<b>Tianshui Huatian Technology Co., LTD.</b>			
Title			
SOM8L POD △			
DWG No.		REF No.	
HTFc0080505			
Unit	REV.	Effective Date	
mm	C	Apr 24, 2017

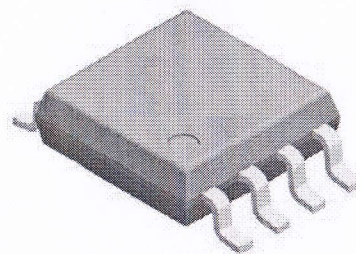
△	Changed E Size, from 7.70/8.10 to 7.80/8.00	WANG Xia	Apr 24, 2017
△	Changed D Size, from 5.18/5.28/5.38 to 5.13/5.23/5.33	WANG Xia	Apr 24, 2017
△	Change product name from VSOP8L (L 27-D1.80) to SOM8L	DENG Xudong	Jan 19, 2016
REV.	Description	Signature	Date
Drafted By	DENG Xudong	Verified By	QI Zhingqiang
Confirmed By	CHEN Guolan	Verified By	HE Naihui
Verified By	HE Wenhai	Approved By	LU Dailie
